**INVITATION TO BID 2024-04
CITY OF PARKER
PARKER SPORTS COMPLEX
PHASE 2**

**ADDENDUM NO. 3
Issued June 10, 2024**

REVISED CIVIL DRAWING PLAN SET

PROPOSED/ALTERNATE CONCRETE SIDEWALK DETAIL
NOT TO SCALE

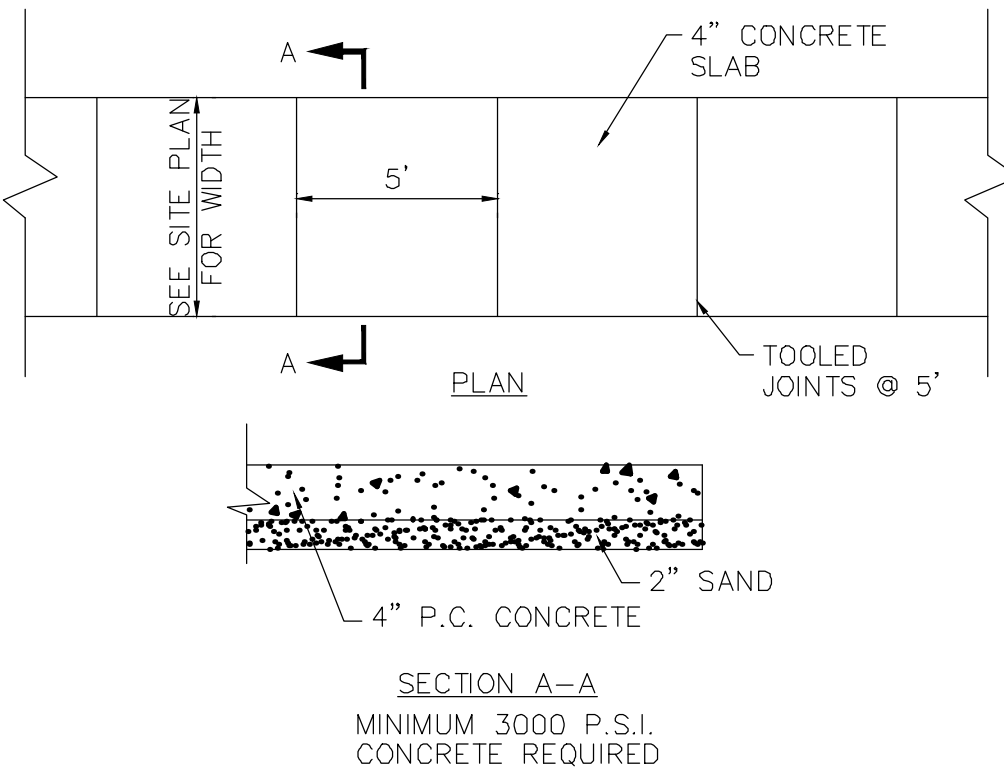
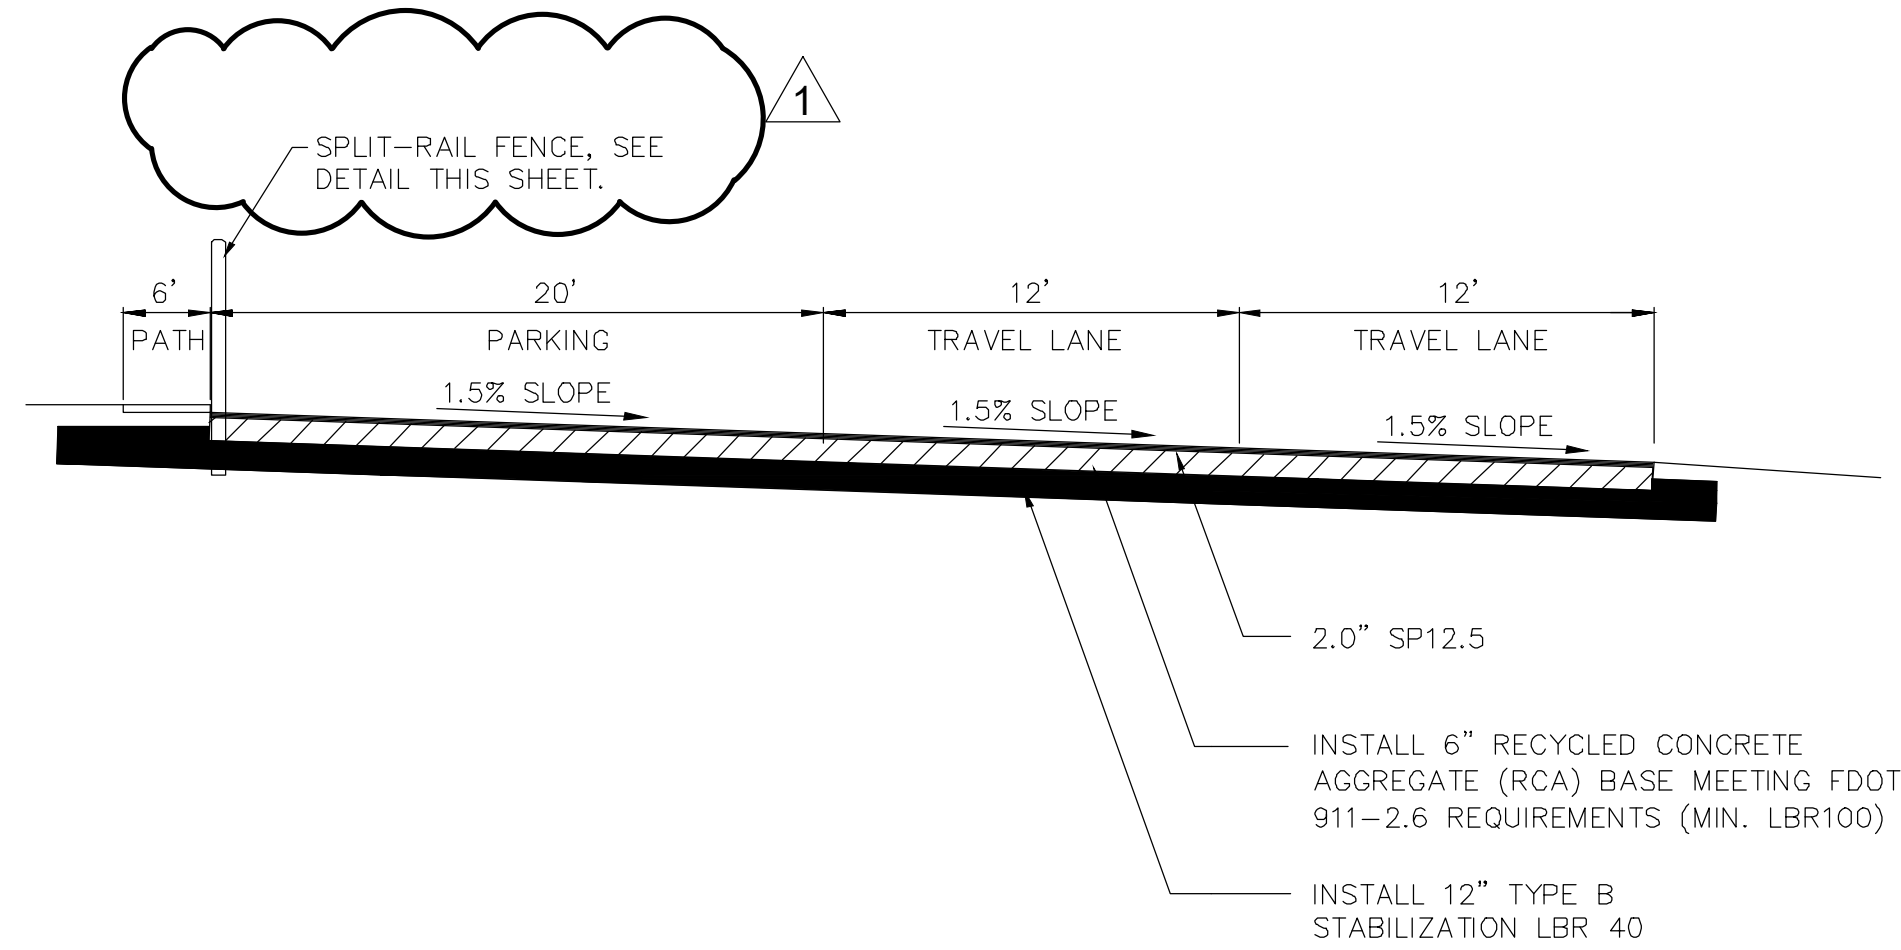
9. Bid Items 6.1 and A2.1 of the Bid Form has been modified to **REPLACE** the width of the concrete sidewalks to 6 feet. *Because of this modification, the Instruction to Bidders, Measurement and Payment, and Agreement have been updated.*

ALTERNATE-B PAVED ROAD AND PARKING DETAIL
NOT TO SCALE

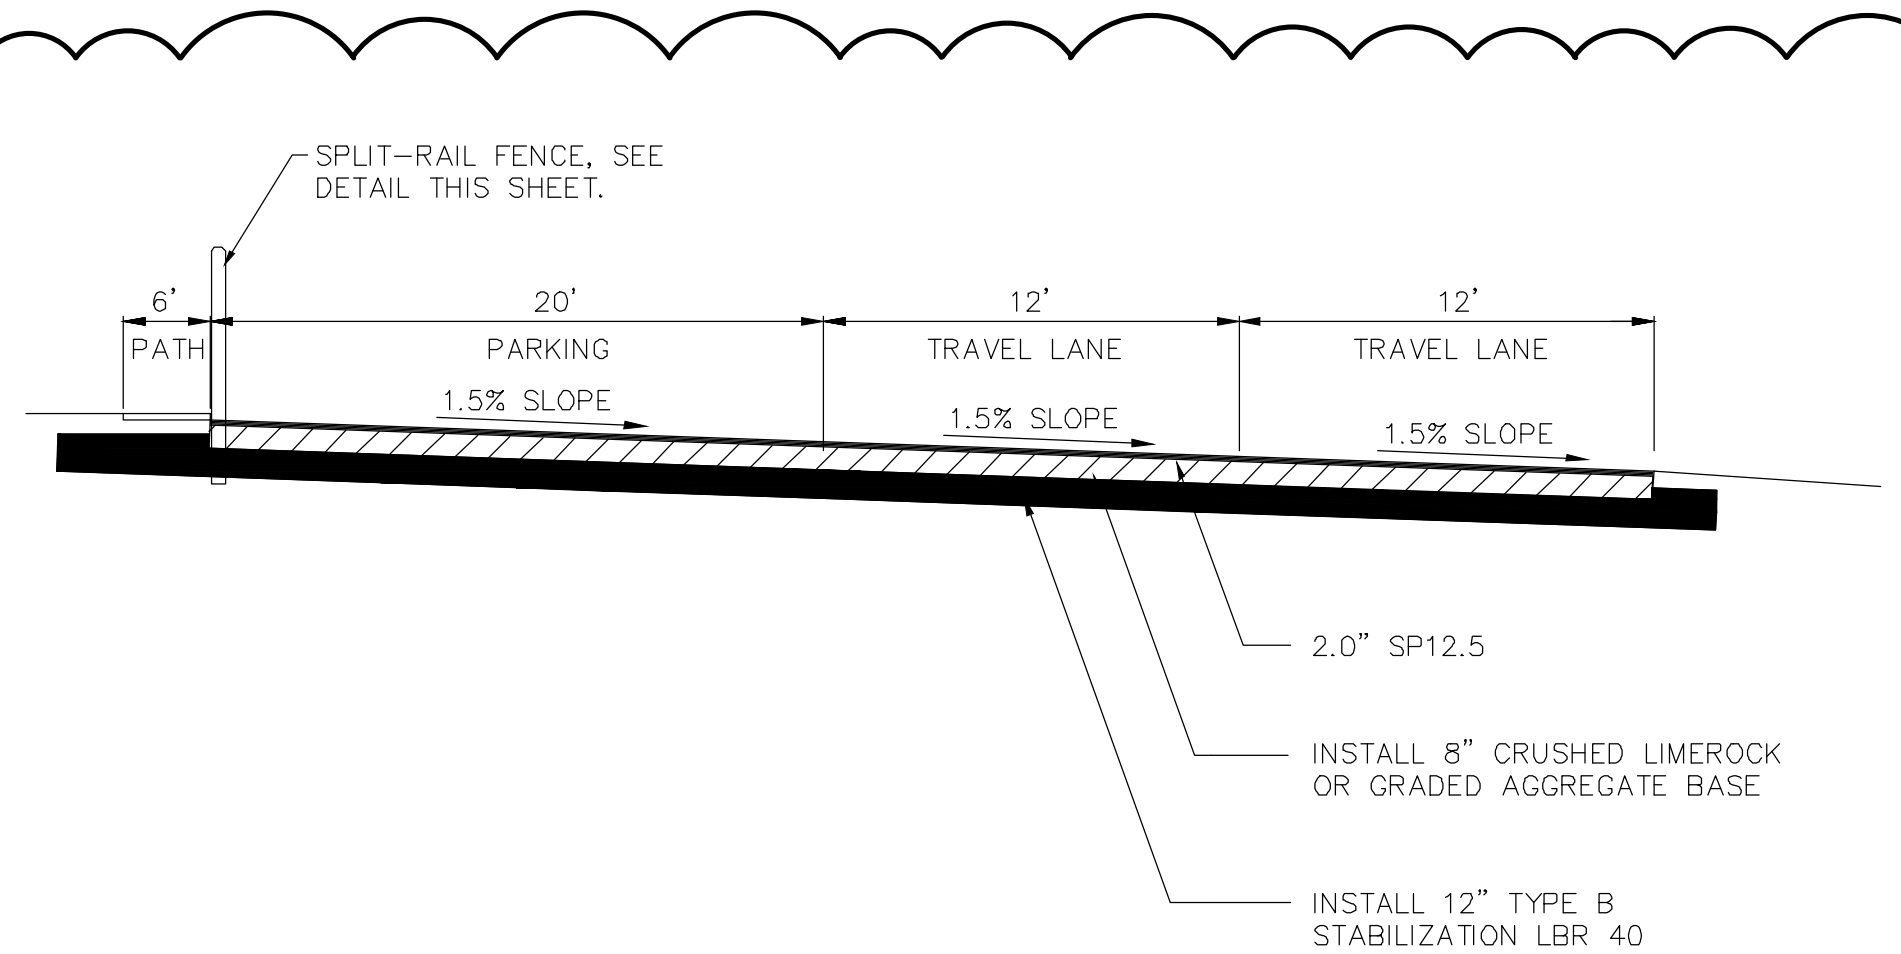
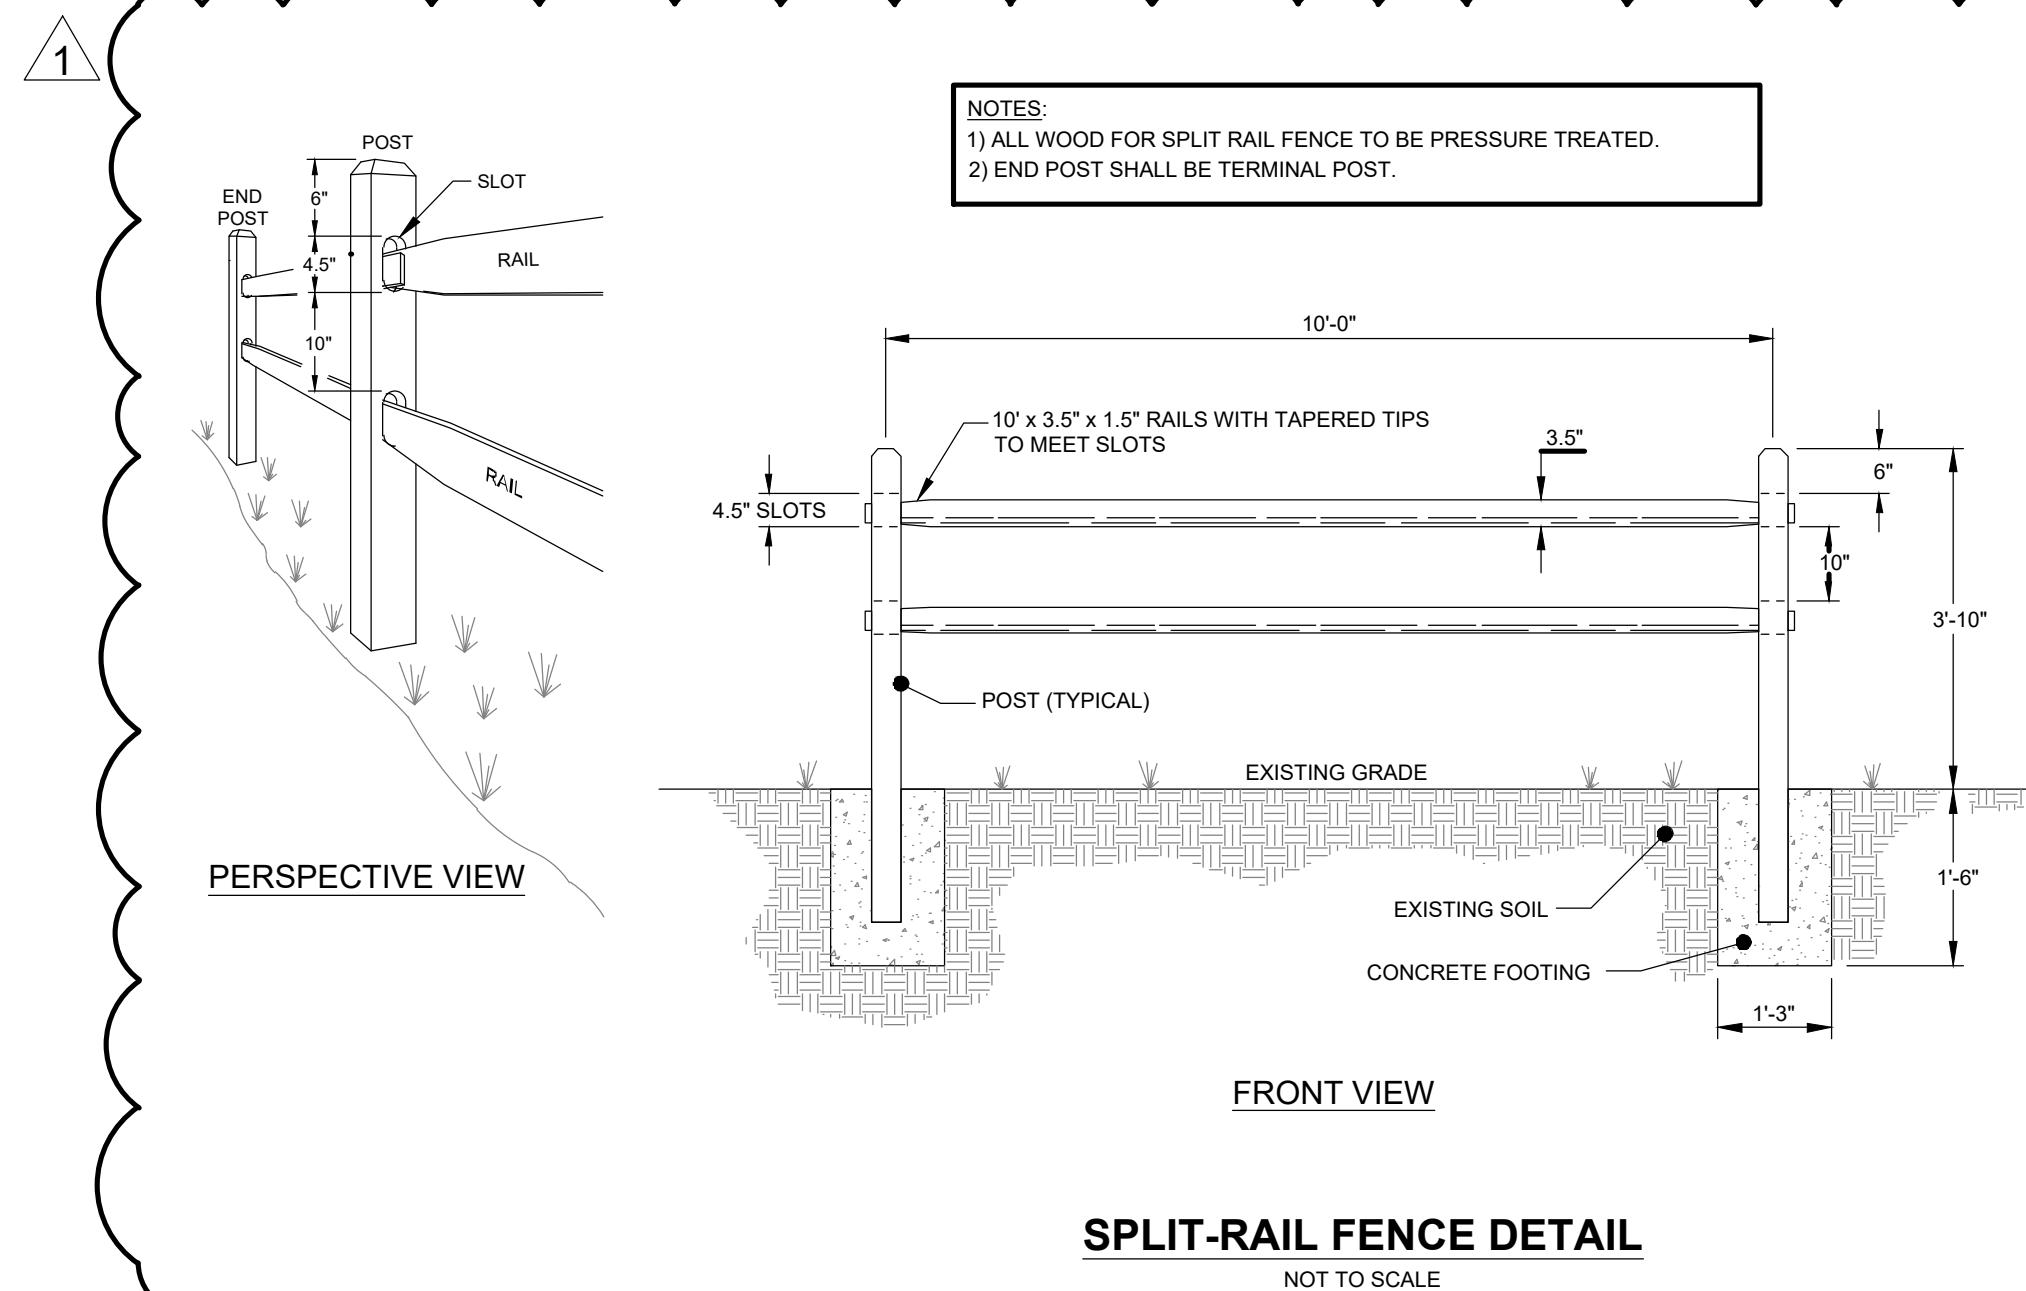
1. An alternate paved roadway design is proposed that incorporates the use of limerock in the place of crushed concrete.
2. All sidewalks and the clay walking path are to be 6-foot-wide per the plans.
3. A modification to the grading plans has been made to the inlet on the west side of the road.
4. A modification has been made to the site grading plan. The intent is for this to be a balanced site that allows the runoff to flow to the pond. Minor adjustments may need to be made to the grades on the west side of the road to achieve the intent.

8. Bid Item B1.1 of the Bid Form has been **ADDED** as an alternate to the paved asphalt roadway with the use of limerock base in lieu of crushed concrete base for the roadway and parking area. *Because of this modification, the Instruction to Bidders, Measurement and Payment, and Agreement have been updated.*
